REQUEST FOR COUNCIL ACTION

AGENDA SECTION: PUBLIC HEARINGS	ORIGINATING DEPT: PLANNING	ITEM NO. E-15
ITEM DESCRIPTION: Amendment to General Development Plan #122 known as Century Hills by Payne Company. The Applicant is proposing to amend the southerly portion of the approved GDP by changing roadway alignments and roadway connections to adjacent roadways. The property is located east of East Circle Drive, north of Silver Creek Road NE and south of Viola Road NE.		PREPARED BY: Brent Svenby, Planner

GENERAL DEVELOPMENT PLAN

GENERAL DEVELOPMENT PLAN REVISION

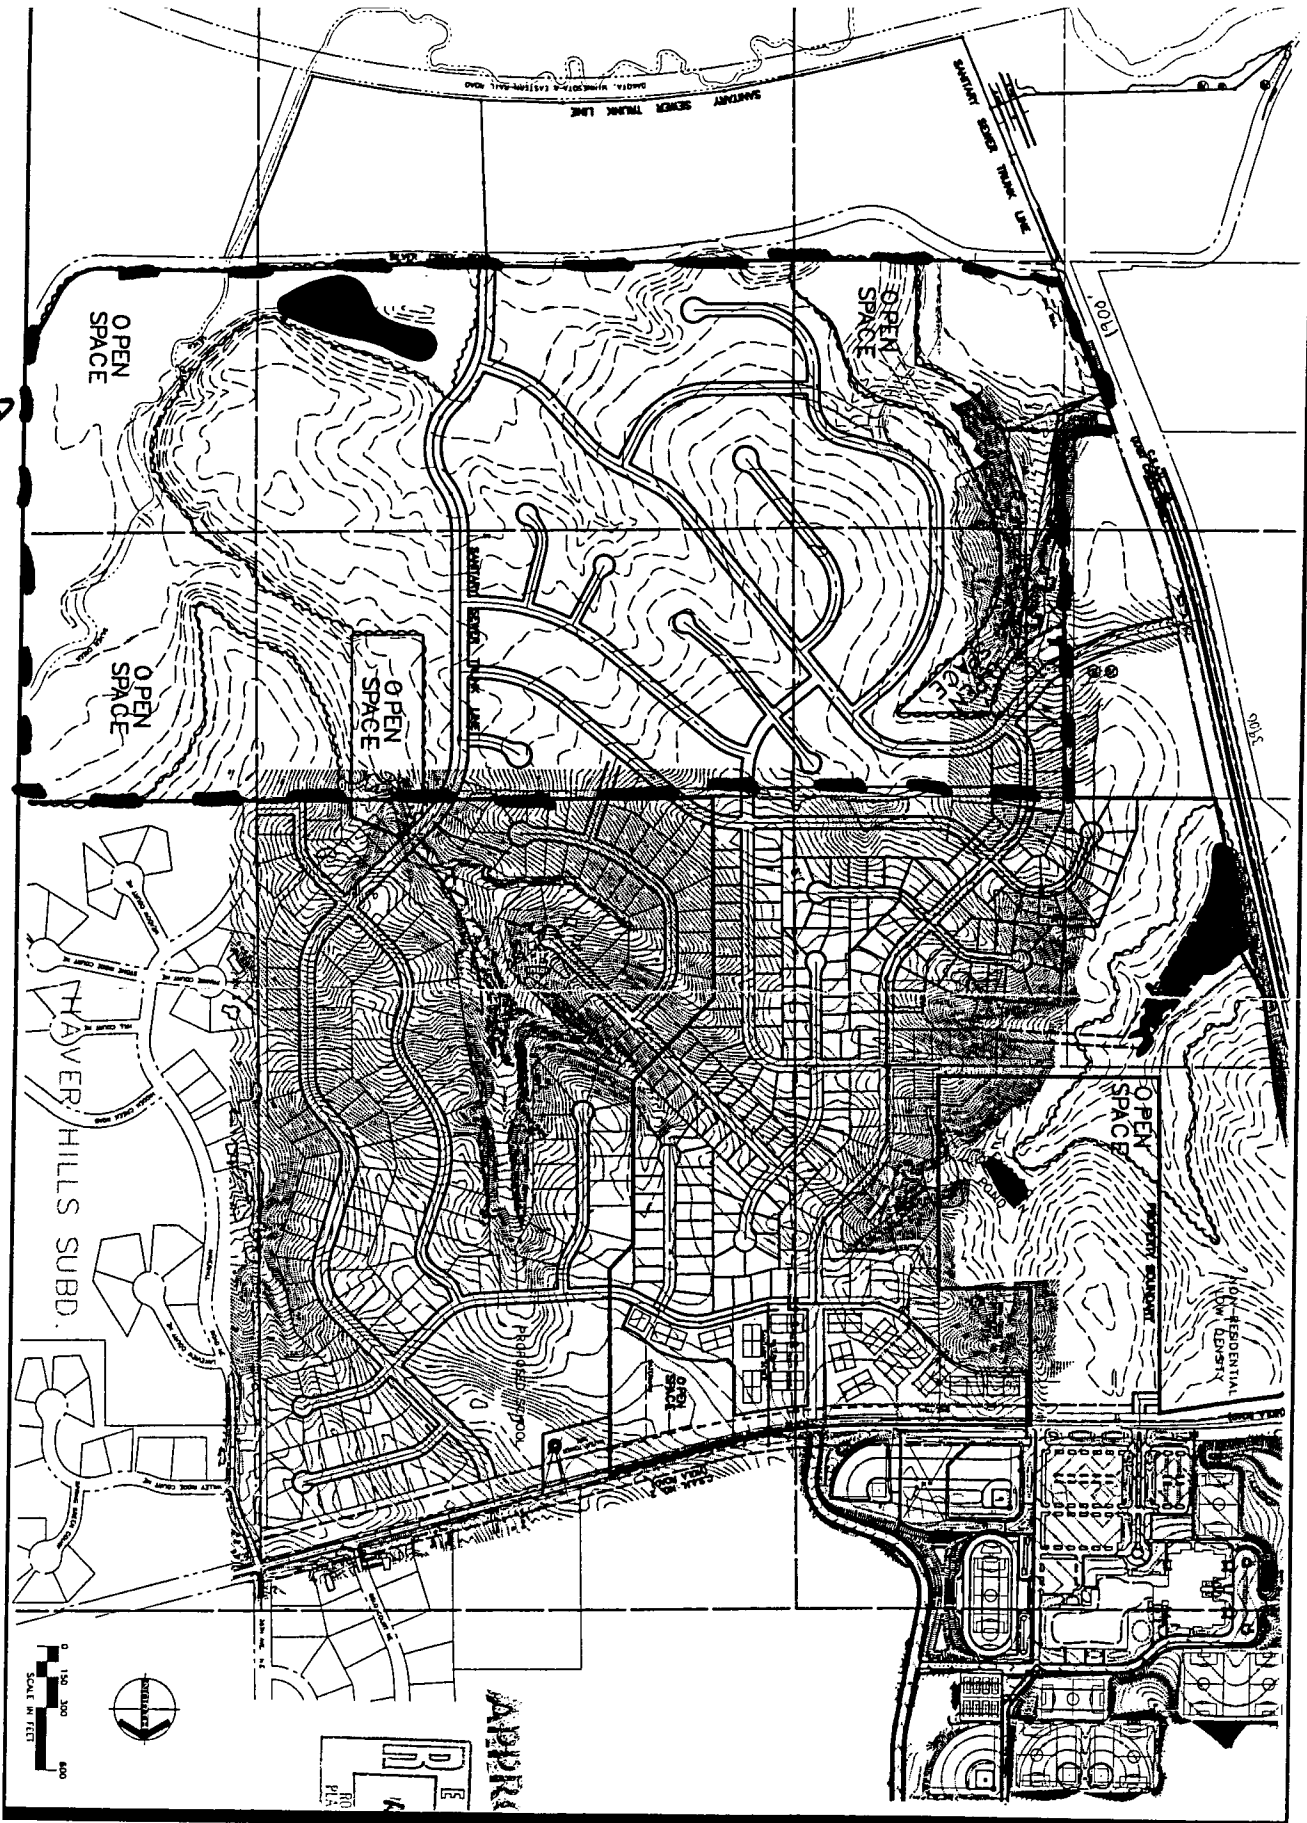
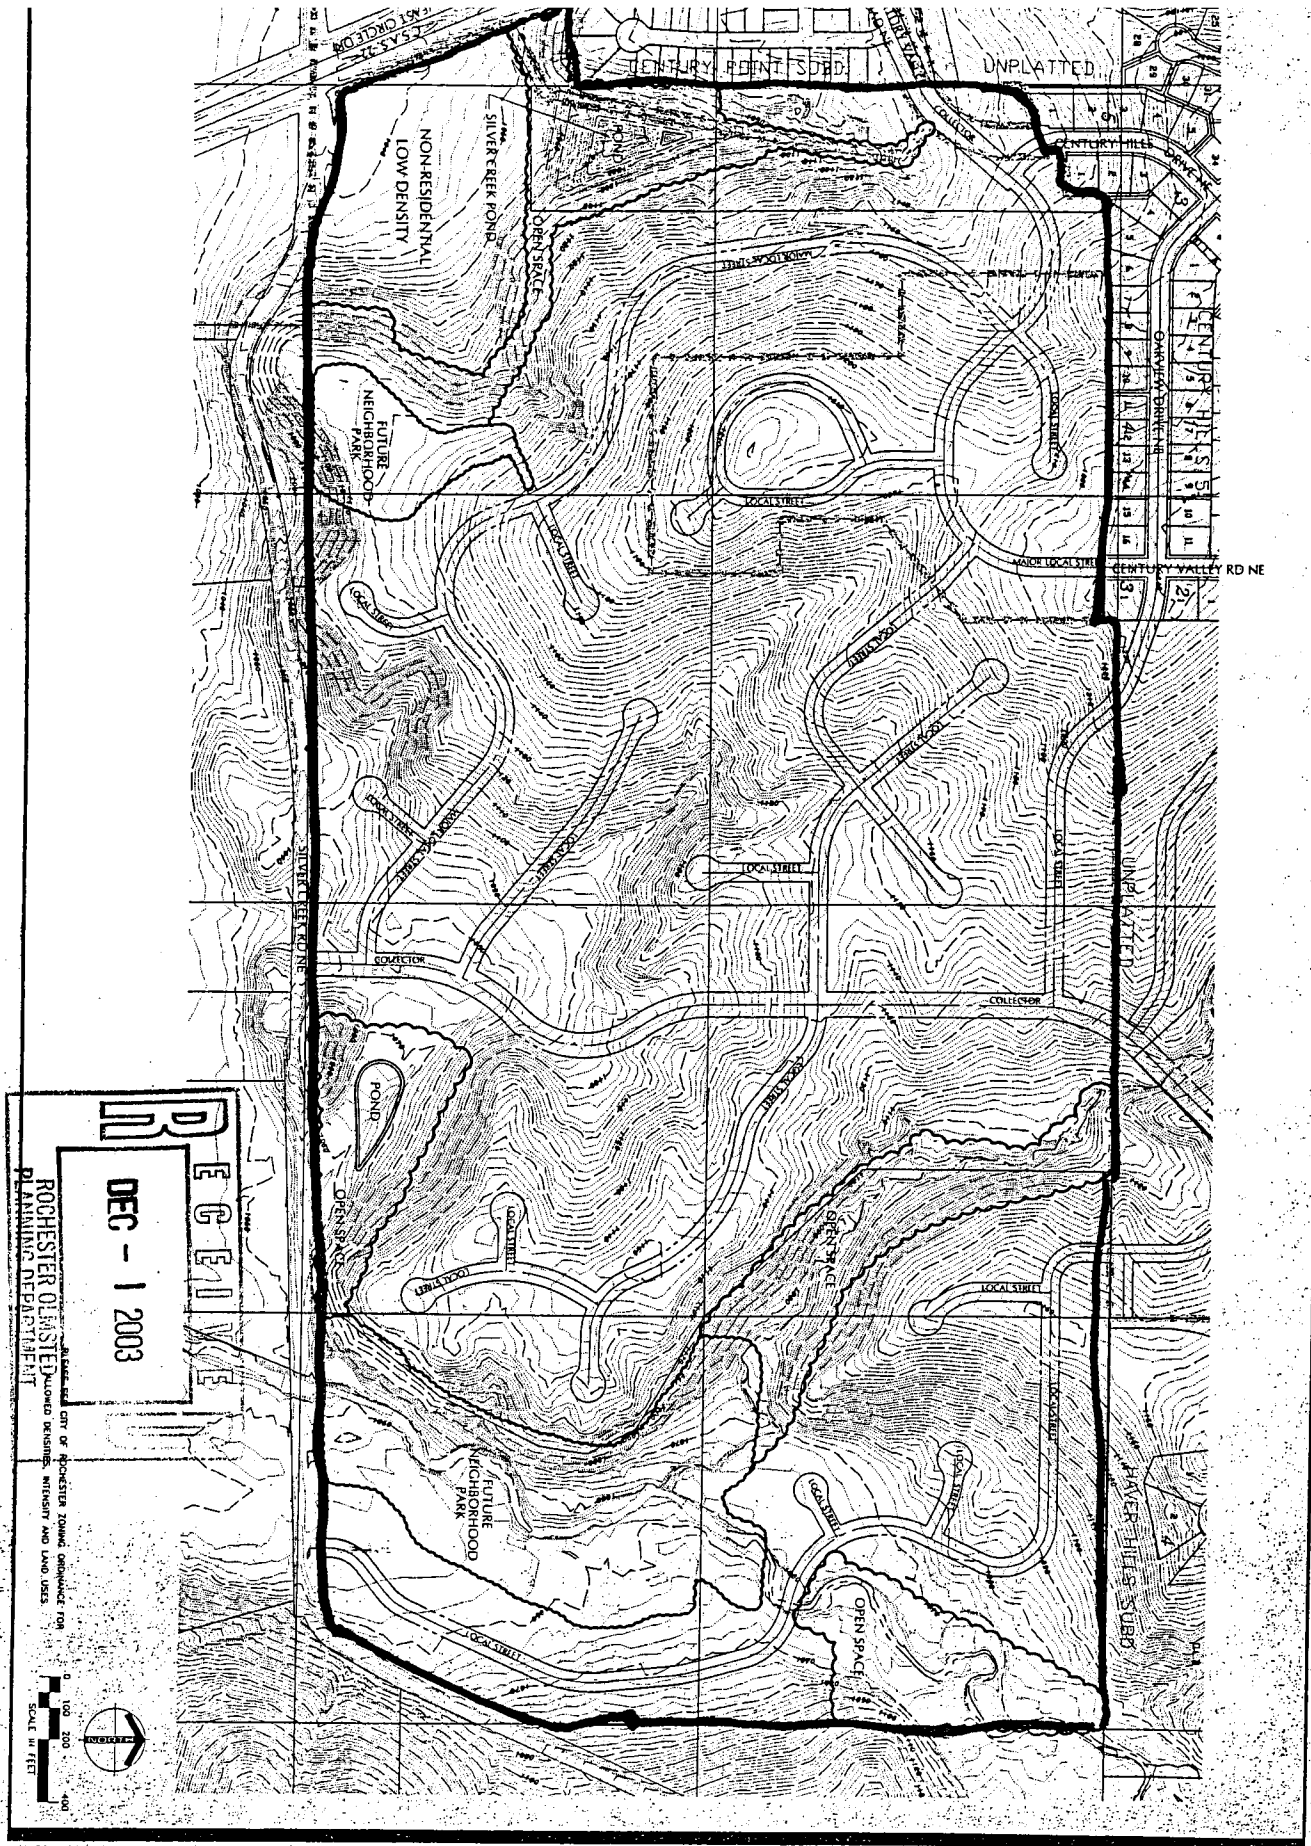
The main reason for the amendment is the fact the roadway alignment in the southerly portion of the property is proposed to be changed. There is also a new proposed connection to Silver Creek Road NE. Attached is the most recently approved Century Hills GDP. As you can see there is major change in the road alignment.

The amended GDP dated 10/20/03 does not provide adequate qualifying land for neighborhood parks. The amended GDP has eliminated a ± 5.5 acre park site (labeled open space on the approved GDP) located in the central part of the development, has eliminated a ± 11.0 acre park site (labeled open space on the approved GDP) in the SE corner of the development and has eliminated a ± 1.5 acres park site (labeled open space on the approved GDP) located in the westerly part of the development.

The Park Department recommends that the amended GDP be revised to show 23.0 acres of parkland. A minimum of 11.0 acres of the land should be land meeting dedication standards. The Park Department recommends that the park sites be located in the same general areas as indicated on the approved GDP with the exception that the open space / park site located on the westerly portion of the development south of Century Valley Road can be eliminated as proposed on the amended GDP.

1. ~~The easterly most local street should be revised to intersect with Silver Creek Rd NE at a right angle.~~
2. ~~Access off of Silver Creek Rd NE should be provided to the proposed "Future Park". It does not appear that the parcels lying between the proposed park and Silver Creek Rd NE are owned by the applicant.~~
3. Storm Water Management must be provided for this Property. Details of the Owner's obligations related to Storm Water management will be addressed in a Development Agreement prior to Final Plat submittal.
4. Portions of the Silver Creek Rd NE may need to be realigned in the future which may require an Amended GDP, and dedication of additional ROW.
5. Traffic Calming measures for the development of this Property will be addressed in the Development Agreement, and / or through the review process during Platting.

The amended GDP dated 11/18/03 was submitted to the Park Department on 11/21/03. This version of GDP adequately addresses the Park Department's recommendation that an additional 23 acres of future neighborhood park land be shown on the amended GDP.

The park access / street frontage to the park located in the SW corner of the development (labeled "future neighborhood park") should be a minimum of 100' in width and be graded such that the park access slope is 4% or less.

The ± 19 acre future park site located in the SE portion of the development includes ± 8.0 acres of land meeting dedication requirements. The amended GDP should include a minimum of 350' of access / street frontage on the northeastern portion of the site. Preliminary site analysis provided by the applicant's consultant showed the 350' access but the submitted GDP did not. Acceptance of this amendment to the GDP should be done with the understanding that none of the proposed future neighborhood park areas are to be the site of storm water detention facilities.
